# **Safety Standards for Excavations**

April 1983

# DEVELOPMENT OF DRAFT CONSTRUCTION SAFETY STANDARDS FOR EXCAVATIONS

Figure 2. Allowable configurations of sloped excavations (cases II, III, and IV are for short-term excavations)

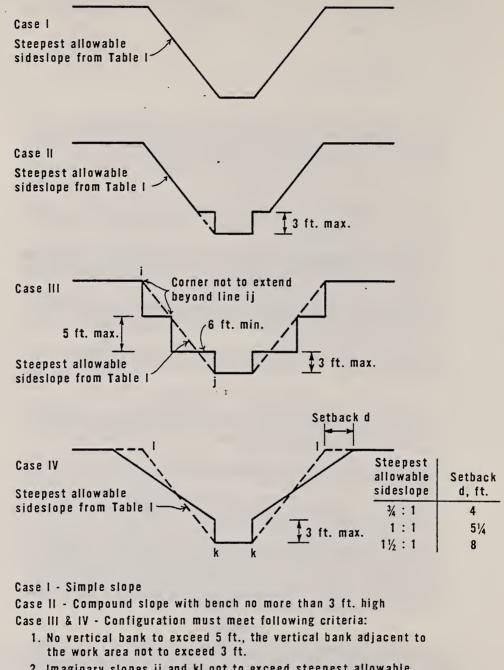
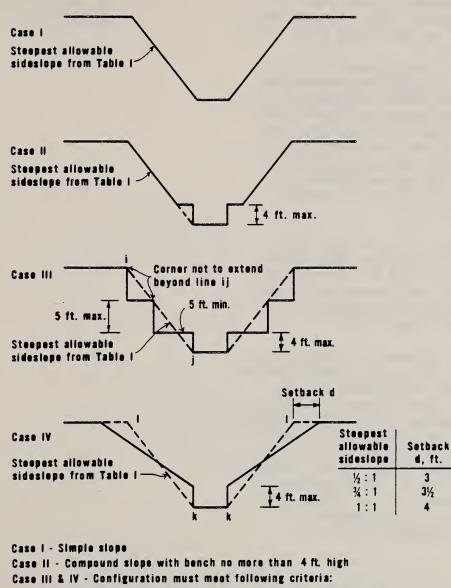
In the Dallas workshop, it was suggested by some contractors to increase the bank to 5 ft (workshop memo). AFL-CIO recommended to leave the allowable height at 3 ft. The point was made that if a large pipe is laid it would provide workers protection against collapse of the bank next to the work area.

- 6. Page 12. Figure 2: Should the allowable bank next to the work area in Cases II, III and IV be increased to 4 ft? Should "Case IV" be limited to excavation by trenching machines?

The revised sketch is a suggestion rather than a recommendation. It is recommended that industry try to reach agreement on the height of the allowable bank.

Figure 3. Determination of Adjusted Depth

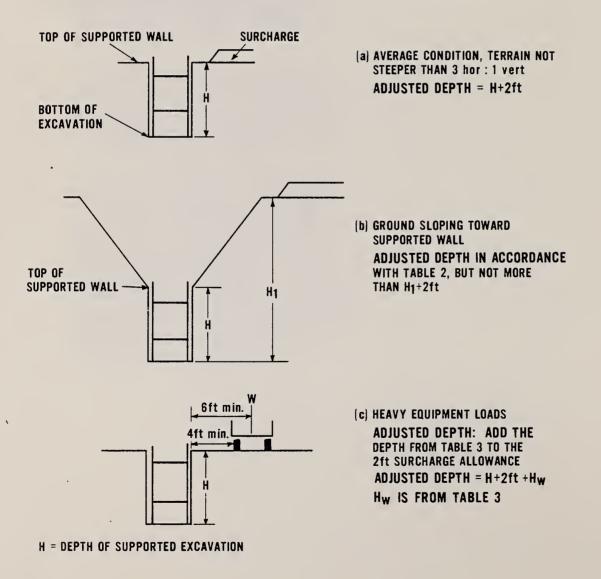
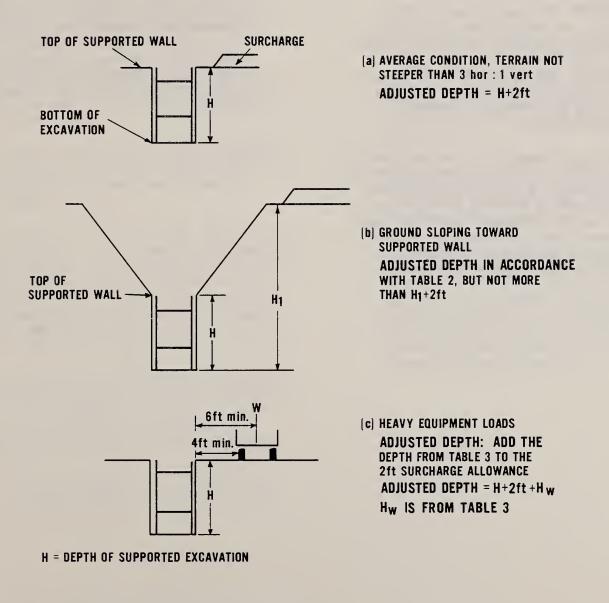
(4)(i) Even though b. and c. require some skill, their application should not be too difficult for a competent person to handle. The alternative of a need to consult a qualified person who is not on the job is even less attractive. The AFL-CIO suggestion of increasing the surcharge requirement in a., and in return eliminating b. and c., would mean in practice that in case b., a backslope of maximum 4 ft. height (H<sub>1</sub> in figure 3b = 4+ 4 ft) could be allowed, and equipment of maximum 20,000 lb. With higher backslope and heavier equipment, an engineer (qualified person) would have to be consulted. If this is acceptable, OSHA could go that route.

It was suggested to eliminate the protrusion of shoring, as this is many times not used, and frequently not desirable as a means of protection agains rolling or sliding objects (Bradberry).

TABLES 2 and 3 NO CHANGE RECOMMENDED
